Subject: 13 Iluka Road Palm Beach NSW 2108 DA 2021/0197 WRITTEN
SUBMISSION: LETTER OF OBJECTION Submission: Dennison-Quirk

SUBMISSION: DENNISON-QUIRK
a written submission by way of objection to DA 2021/0197

Re:
13 Iluka Road Palm Beach NSW 2108
DA 2021/0197

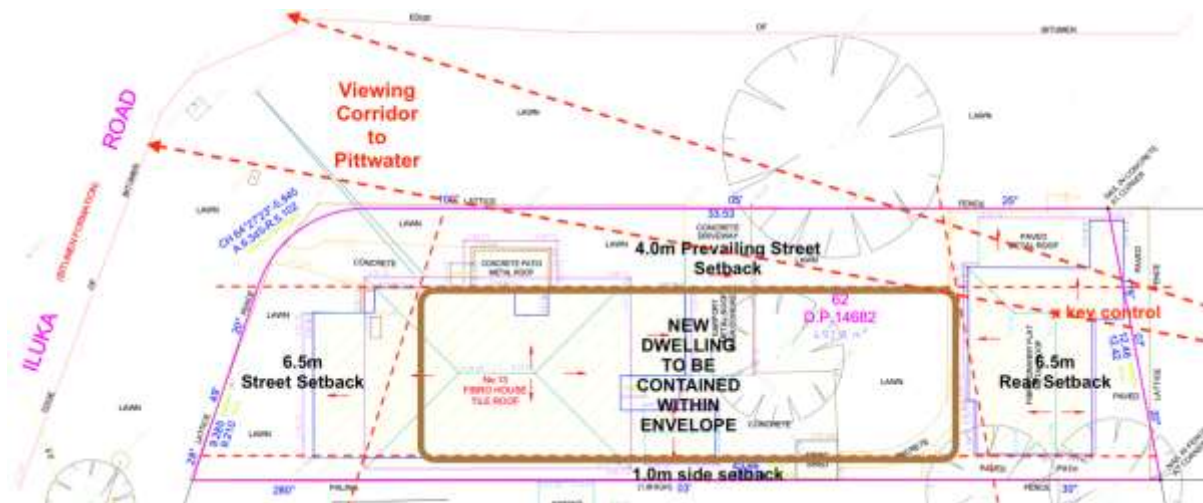
The 'key control' to avoid the devastating view loss is located on the attached marked up survey drawing. The northern end of the roof of the existing Granny Flat is the location from which the view is lost in an arc from the west to the north-west. A compliant 6.5m rear setback, coupled with a compliant 4.0m prevailing street setback, being the existing main dwelling on the subject site, would maintain the view. Any proposed development would need to be tested by a 'height pole' at the 'key control', and preferably prior to any redesign commencing to better inform the design outcome.
